TITLE: Camry / GS450 Breakout		REV: 1.0
EasyEDA	Company: Mack-e-	Sheet: 1/1
	Date: 2020-09-28	Drawn By: mackelec

TITLE: Drive Interface		REV: 1.0
EasyEDA	Company: Mack-e-	Sheet: 1/1
	Date: 2020-10-05	Drawn By: mackelec

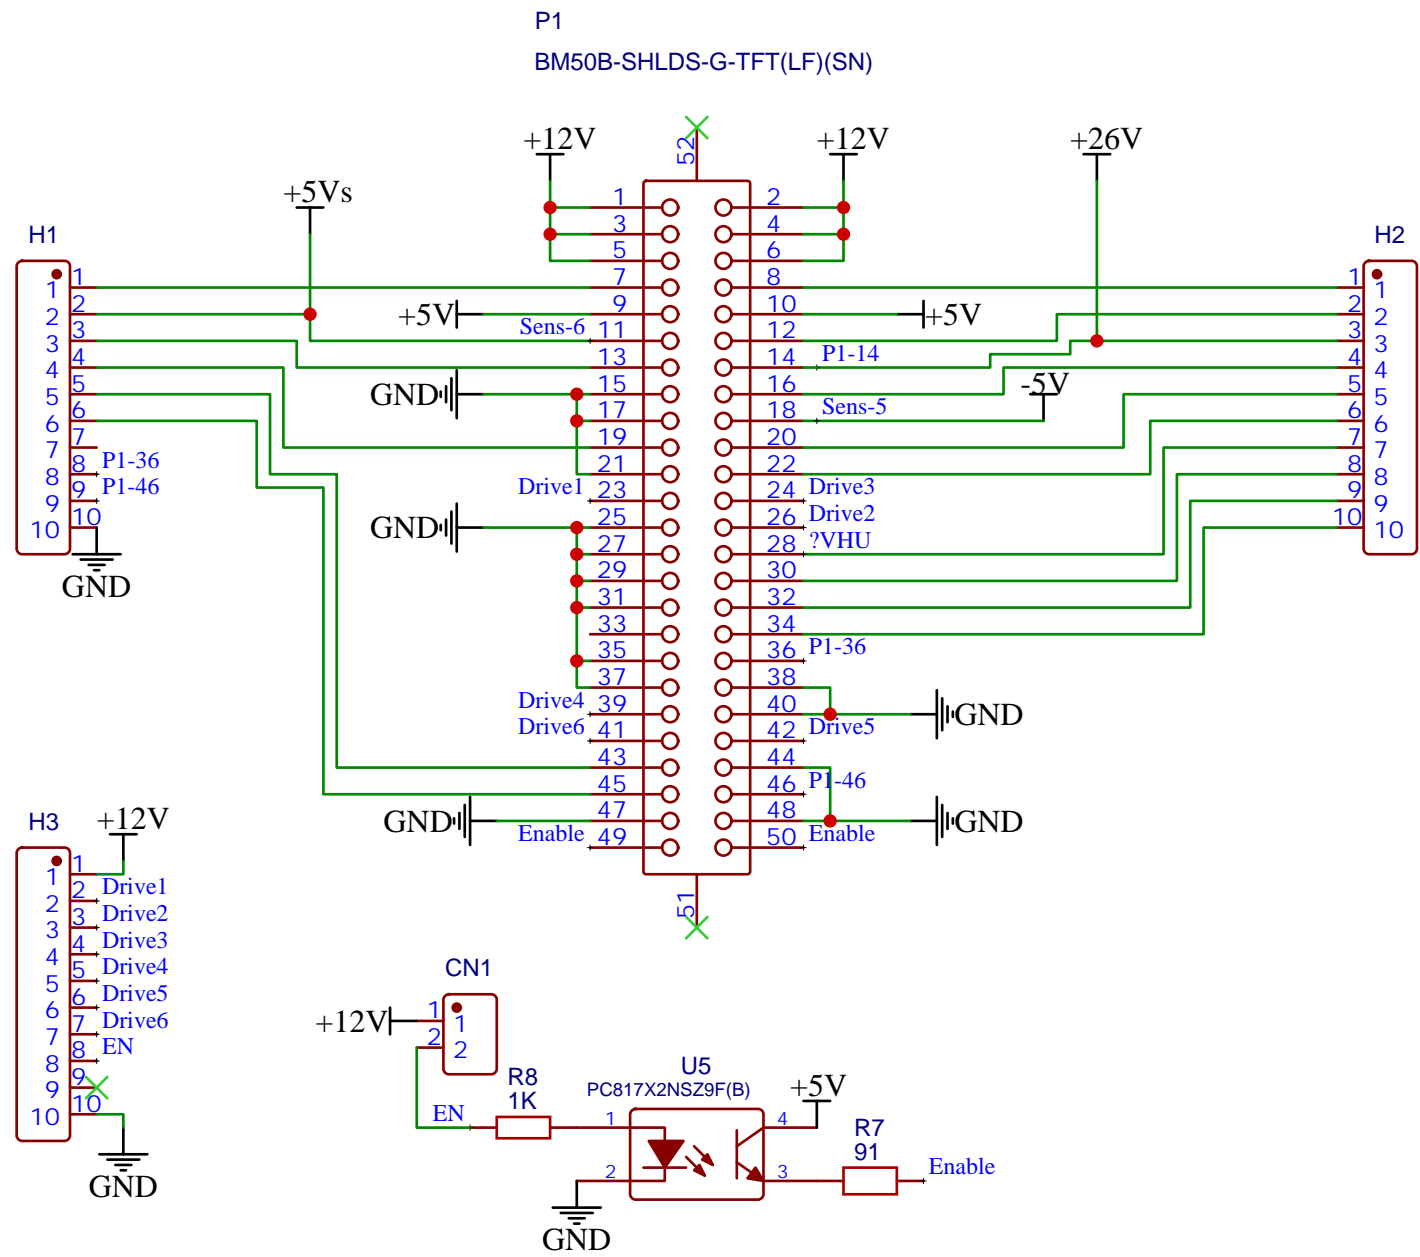
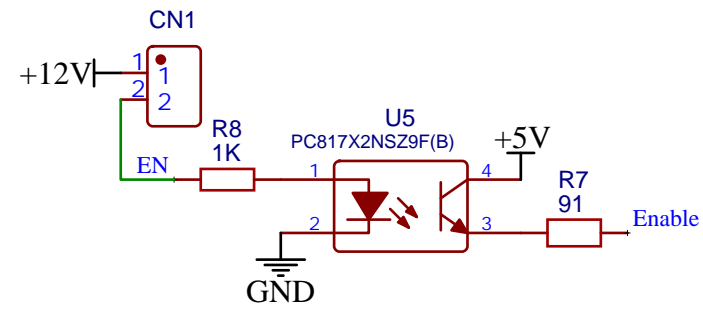
Connector Pins not laid out to JST spec

?VHU = Bus Voltage ?
